**SUBMISSION ON STATE SIGNIFICANT DEVELOPMENT (SSD) APPLICATION  
ENVIRONMENTAL IMPACT STATEMENT : Sydney International Convention, Exhibition  
and Entertainment Precinct (SICEEP) SSD 5725 – Public Private Partnership (PPP)  
Component and SSD 5878 – The Haymarket Component**

I live next door to the proposed Darling Harbour South redevelopment and I object to both proposals – SSD 5725 and SSD 5878.

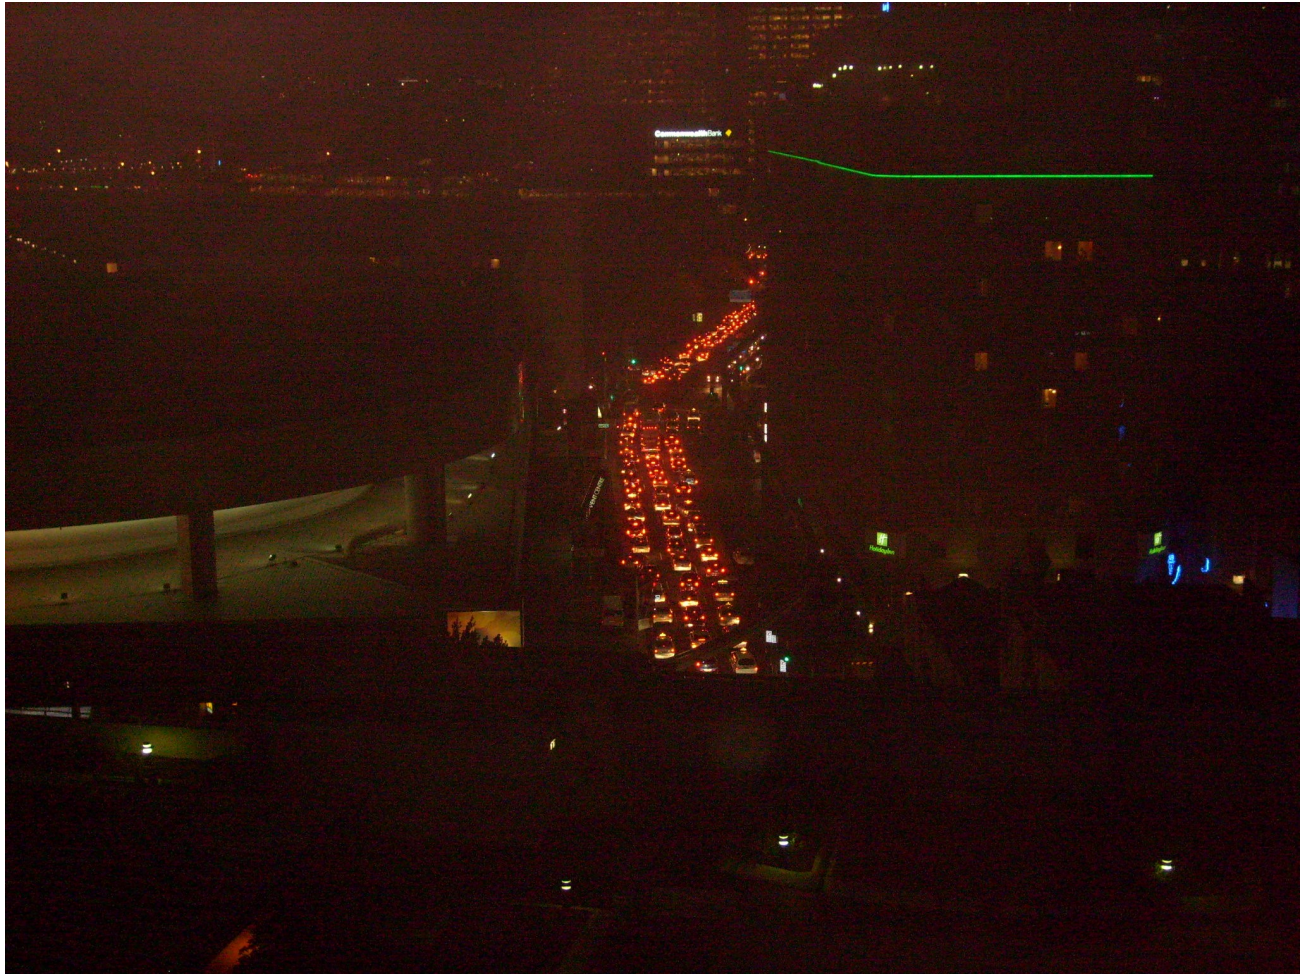
**A queue of infinite length ?** Note the northbound signals of Harbour Street at Goulburn and Pier Streets are at green. This was a Friday night and the picture remained the same for ½ an hour. The “queue” continues to the right left hand corner back into Hay Street (obscured by the garden wall of The Peak apartment block’s podium) from George Street.

**Recommendation to the Department of Planning and Infrastructure (or the PAC, if relevant) :** Immediately, refer the traffic and transport modules supporting the EIS to Transport for NSW and NSW Roads and Maritime Service for :

- a detailed review of their adequacy as a comprehensive account of the traffic and transport impacts of the entire proposal (both SSD 5752 and SSD 5878) , and if found to be less than complete;
- suggestions for their revision so as to make their proper contribution to Planning and Infrastructure (or PAC, if relevant) decision makers charged with considering these key factors for both SSD 5752 and SSD 5878.
